EASTERN CORRIDOR SEGMENTS II AND III (PID 86462)

COMBINED LINWOOD/EASTERN INTERCHANGE & US 50/RED BANK INTERCHANGE FOCUS AREAS ADVISORY COMMITTEE MEETING NOTES

February 14, 2018
May 22, 2018
September 7, 2018
December 12, 2018

Drawing was presented at the October 24 & 25 Open House meetings.

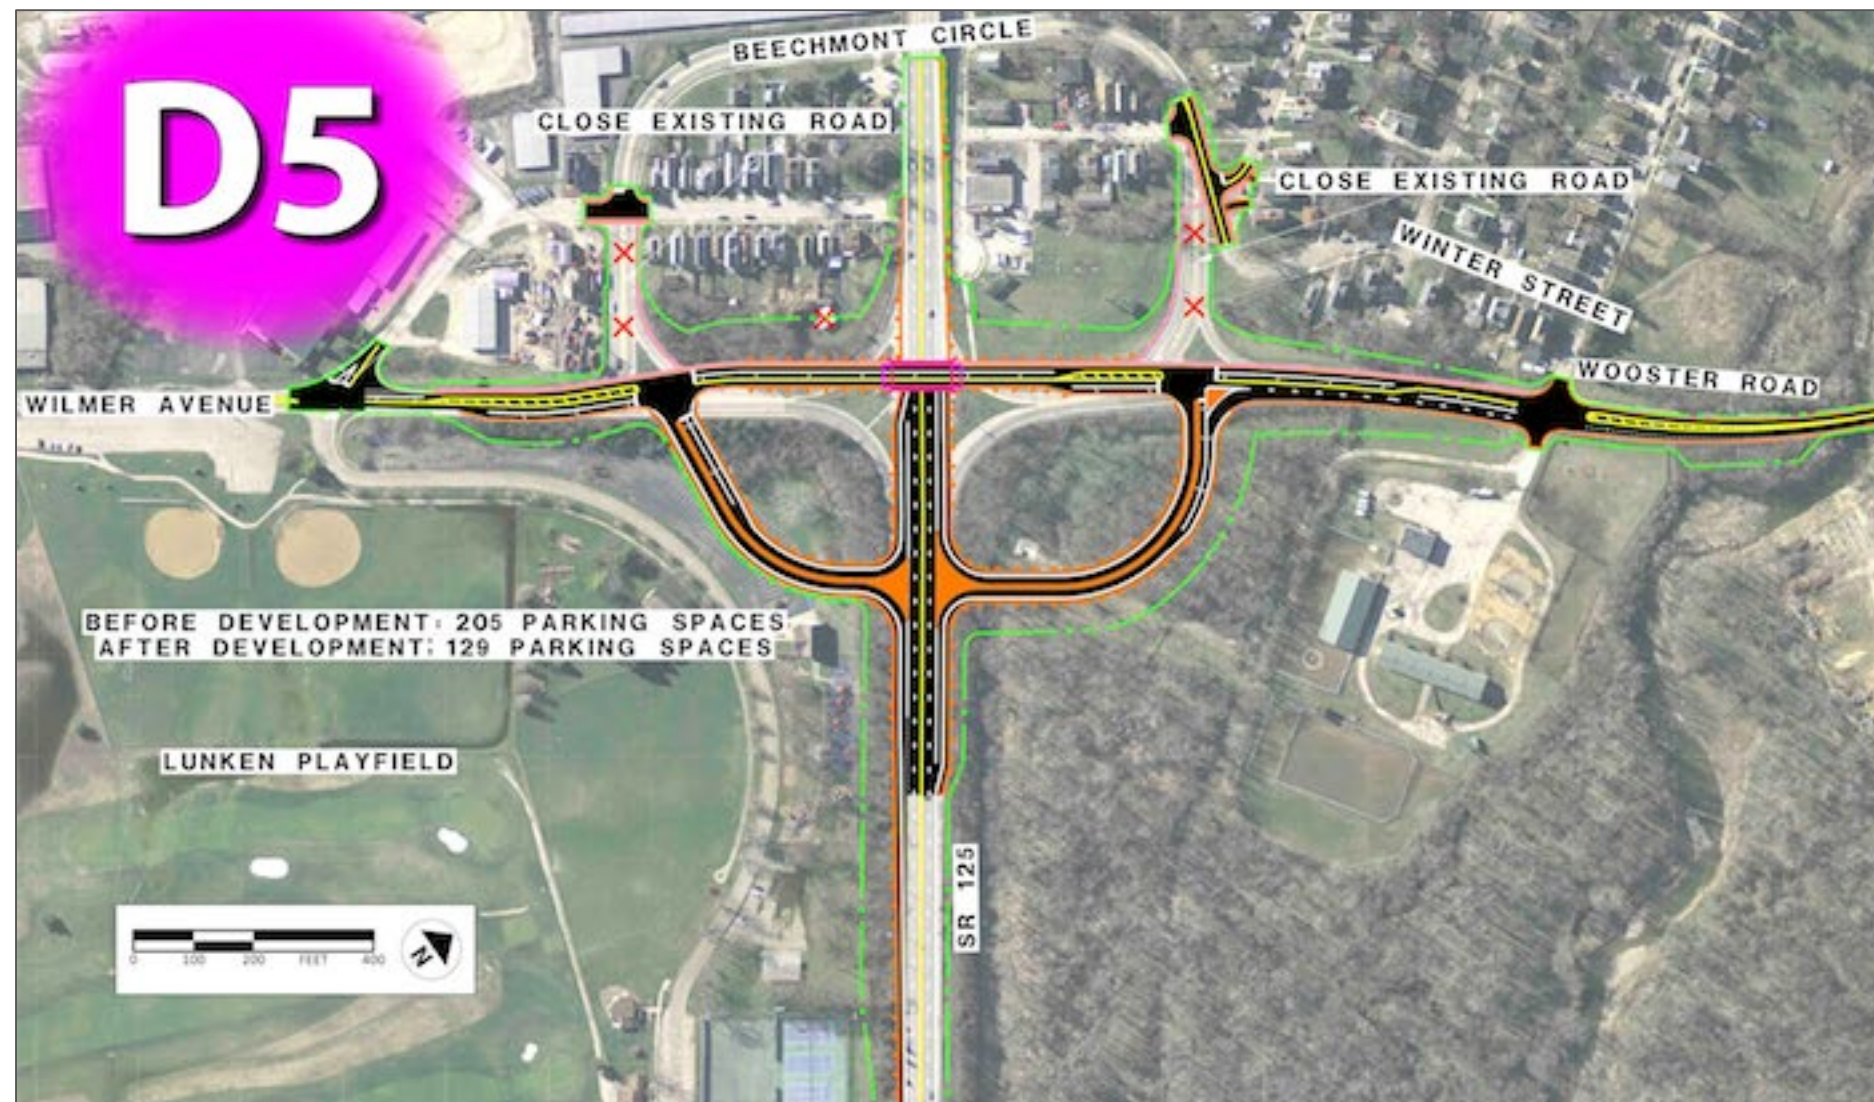
- This concept offers a lower speed connection to Wilmer Avenue and Wooster as compared to concept X-2b-3.
- The Wooster/Wilmer interchange would bridge over SR 125.
- Offers a clear connection between Wilmer and Wooster.
- Concept would take through-traffic off Beechmont Circle; streets within Beechmont Circle would be used for local traffic.
- Would need to add a turn lane to Hutton Street from Wooster.
- Concept would impact the locations of existing bus stops; bus stops would have to be relocated.

- Comments Submitted Following the 5/22 Meeting**
(Comments are presented as submitted by Committee members; no edits to content were made.)
- Will the three-way intersections on either side (East and West) of the proposed grade change connection of Wilmer and Wooster be signalized, or stop signs? Concern this will slow flow of traffic compared to current design.

- ODOT Response:
- The intersections would either be signalized intersections or reconfigured into roundabouts.

Figure X-2B-2A

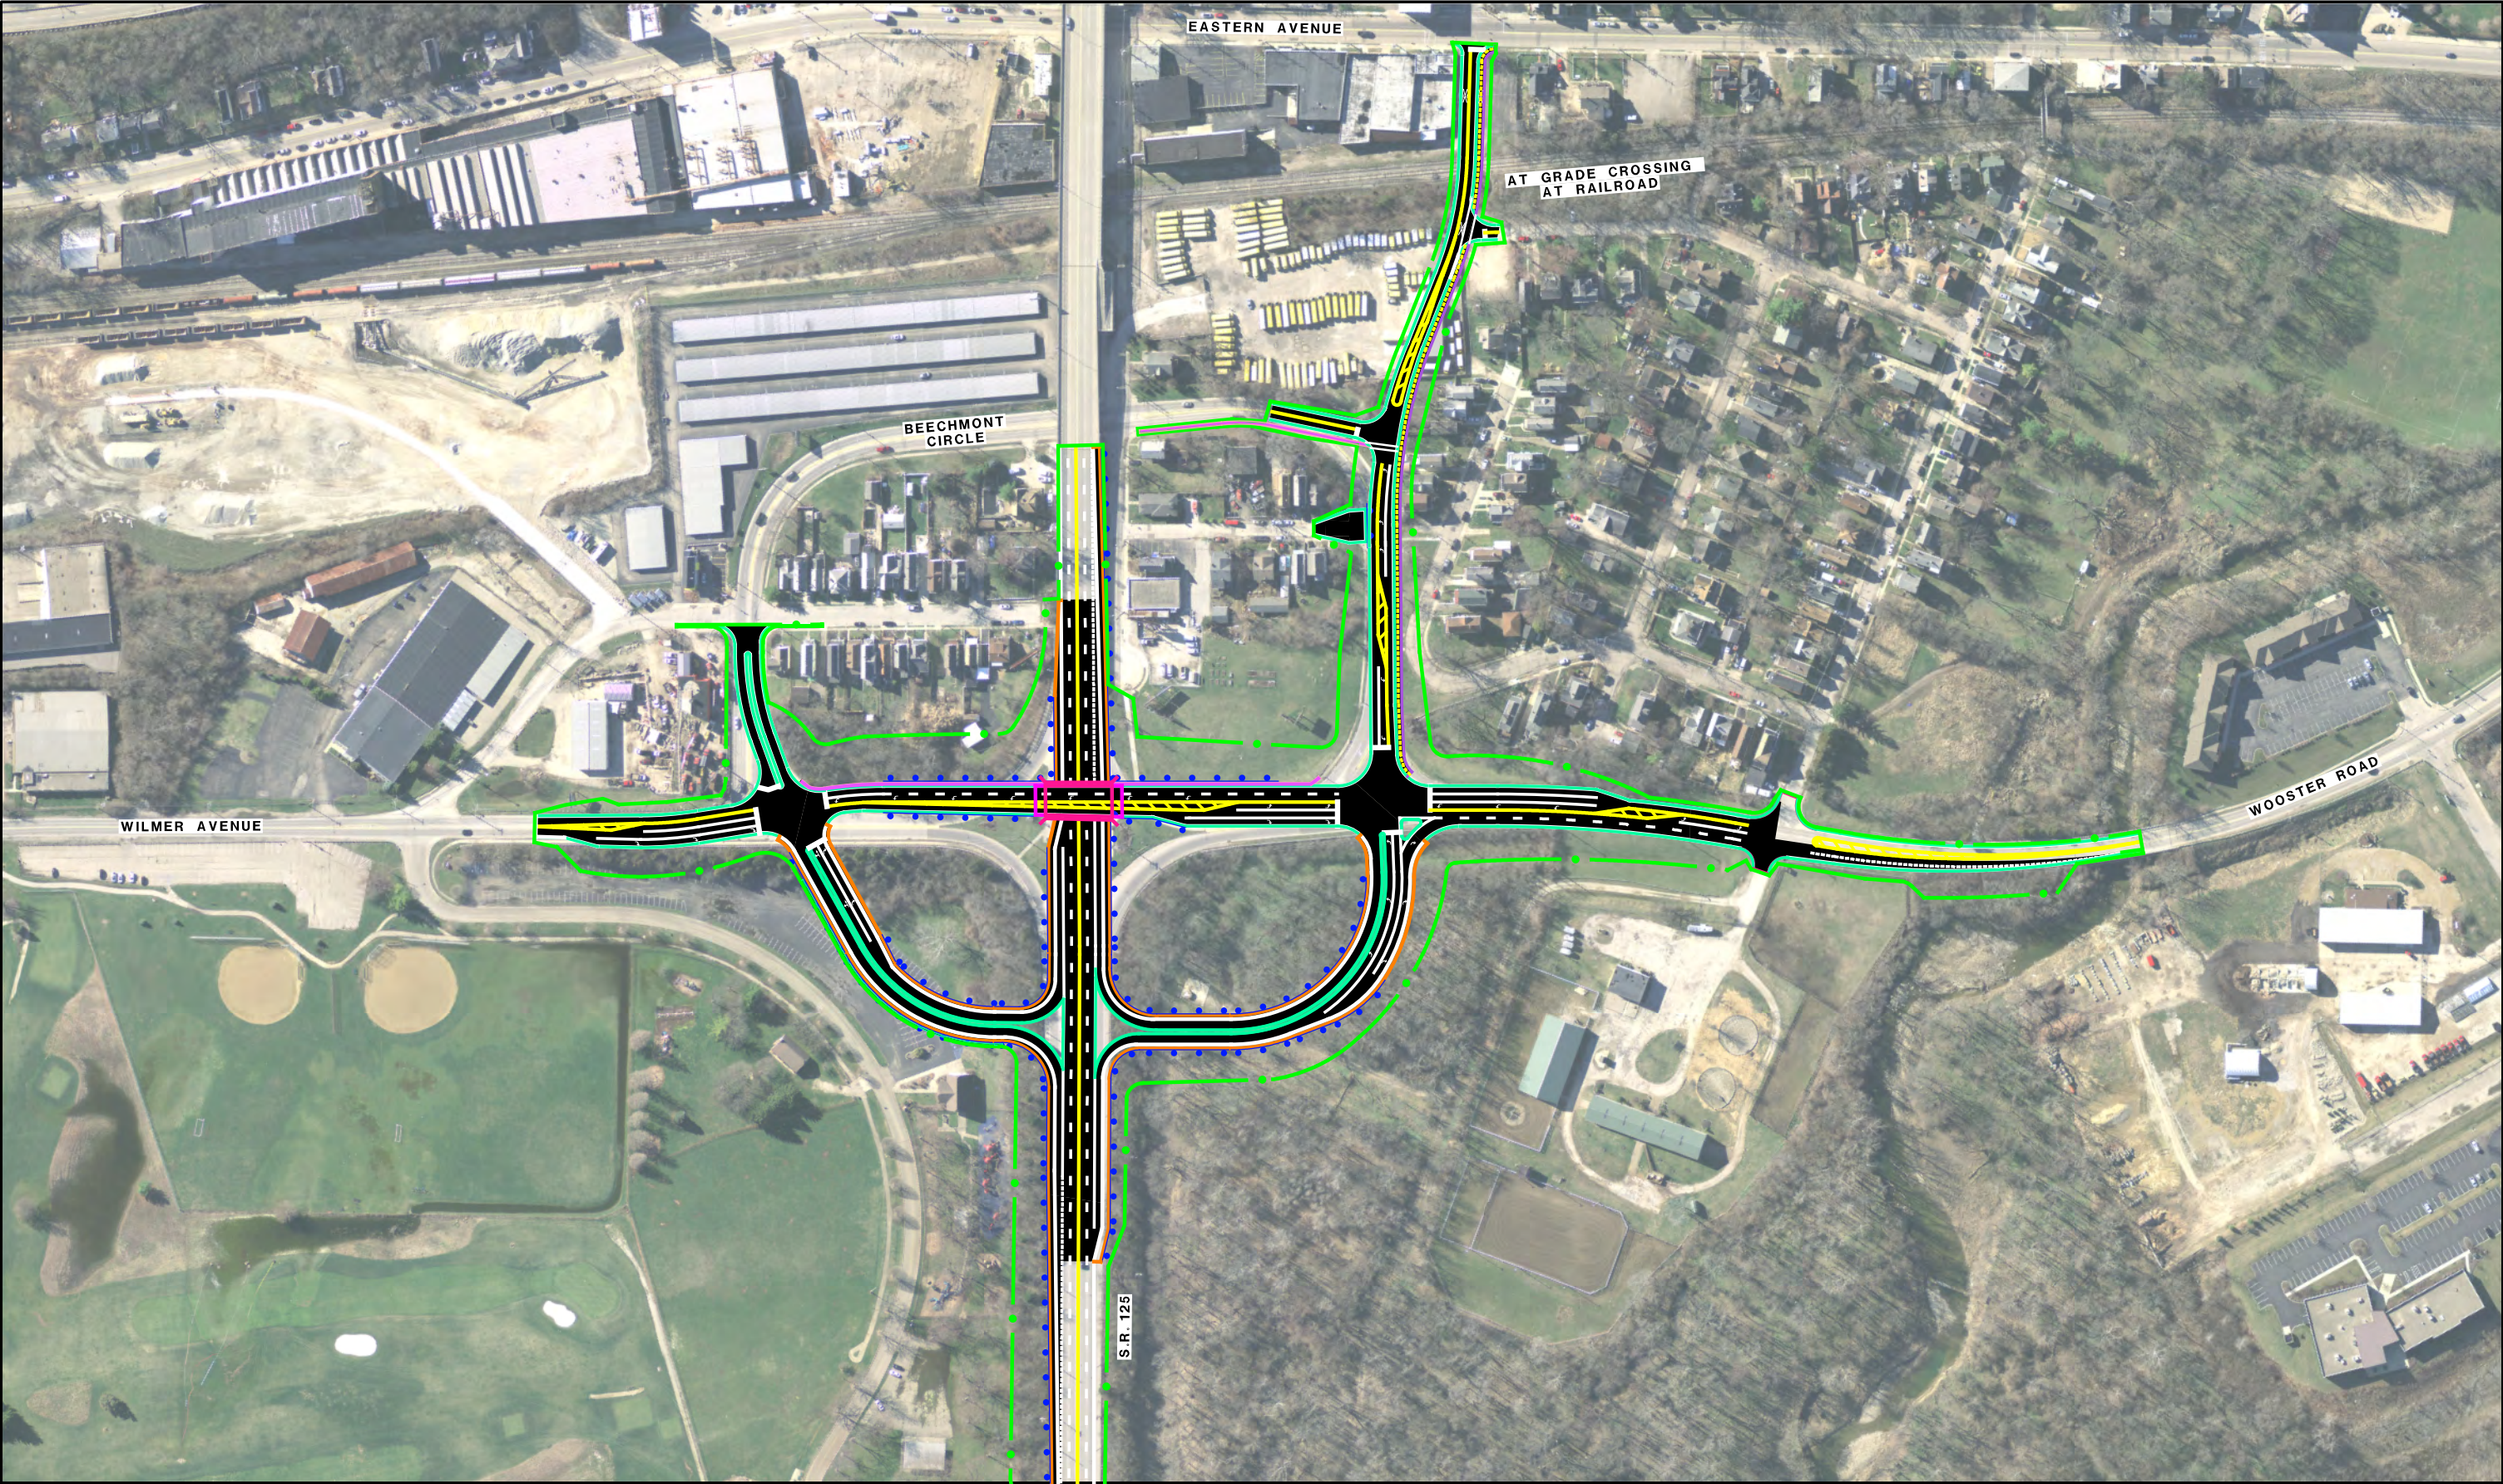
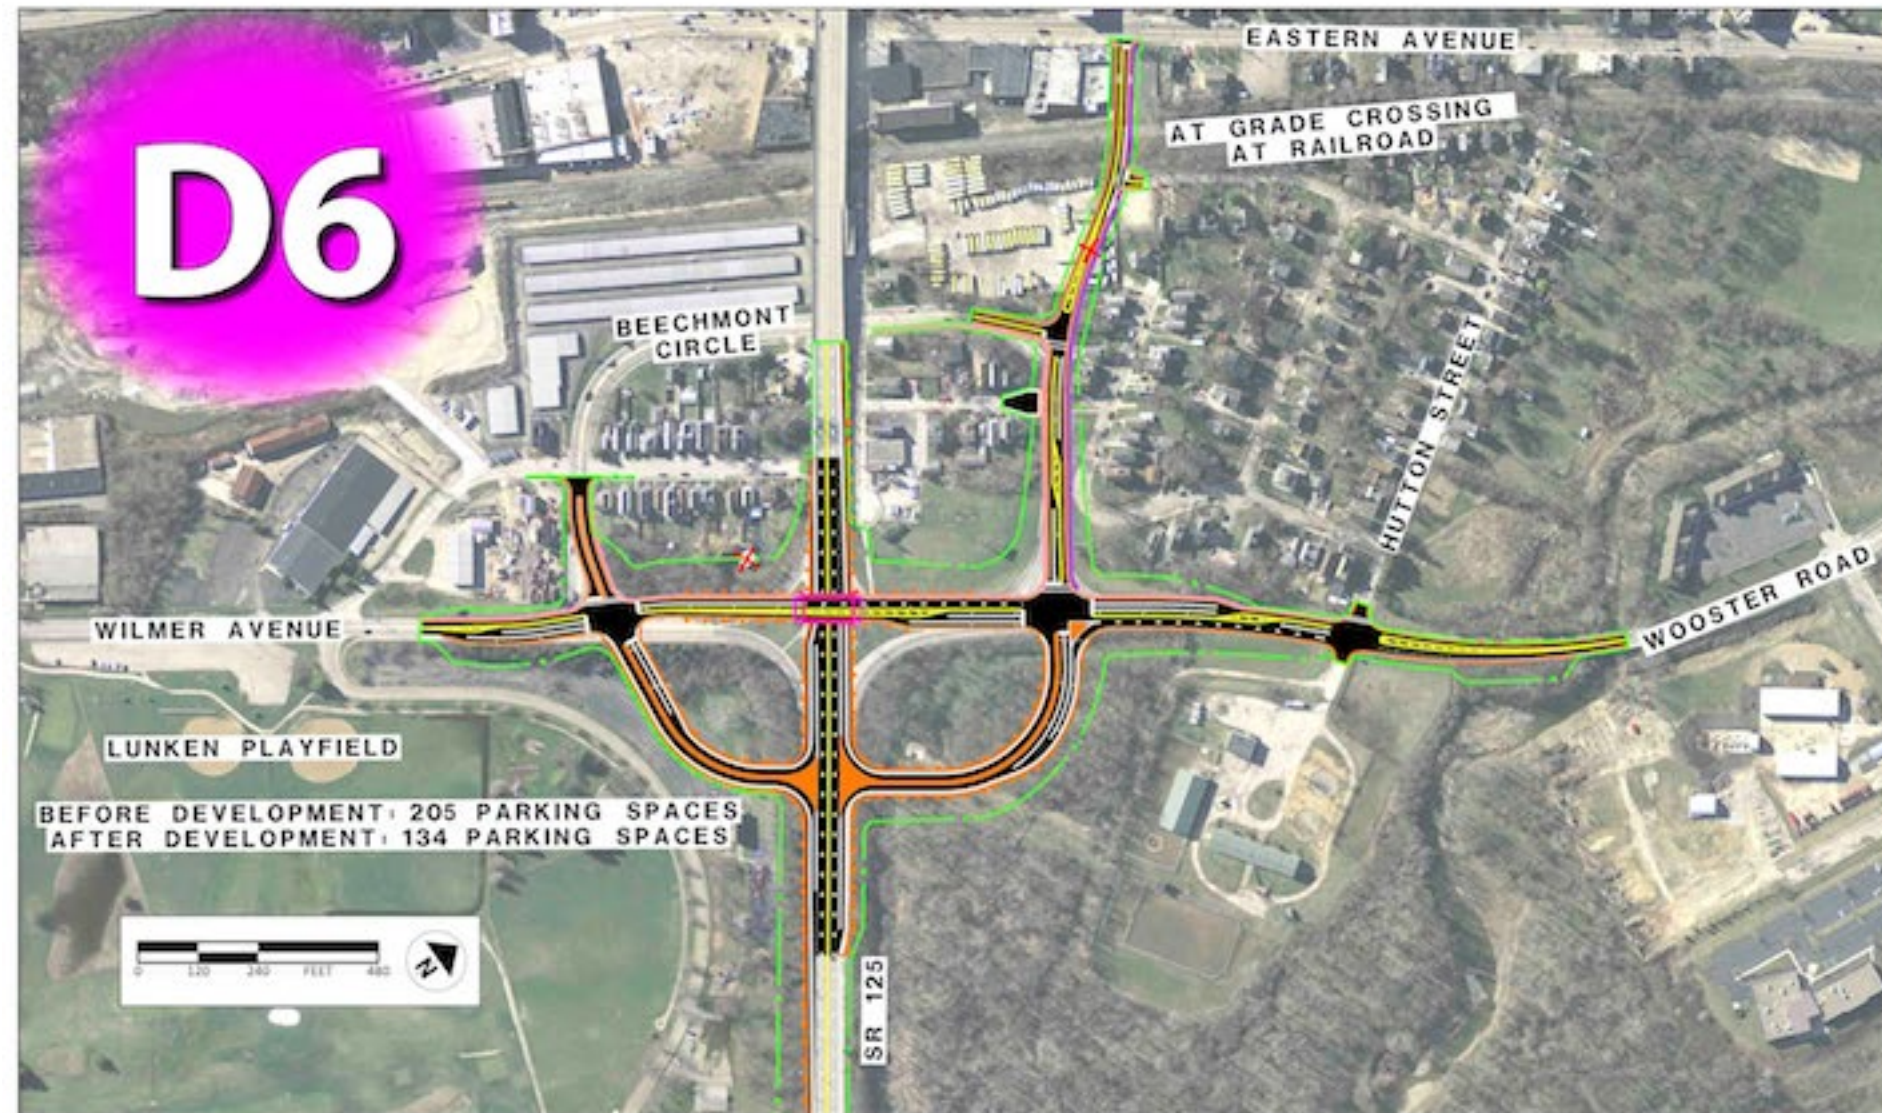
- This alternative should be evaluated with X-2b-2a and X-2b-5.
- The concept connects Wooster and Wilmer over SR 125. Wooster and Wilmer would connect with SR 125 using T-intersections (although the Wilmer/SR 125 connection may have to be adjusted somewhat).
- This option would pull commuter traffic out of two small subdivisions. (Note: A goal of the Linwood Neighborhood Plan is to remove commuter traffic from the neighborhood).
- This concept would result in the loss of parking spaces in the Lunken Playfield parking lot, though the number of spaces lost is not yet known.
- No additional comments received following the 9/7 meeting.

- For some committee members, a primary concern relative to pedestrian safety was the location of the bus stop on Beechmont Circle. The group discussed the possibility of adjusting the bus stop to provide space for buses to pull off the road instead of stopping on the shoulder.

- Revisit concepts/perform additional study to determine if a lower-cost option can be developed to improve pedestrian safety.
- Engage the Linwood Community Council to further vet the two concepts [X-2b-2 (D5) and X-2B-2A (D6)].
- Include X-2b-2 (D5) and X-2B-2A (D6) in the Implementation Plan as low priorities.
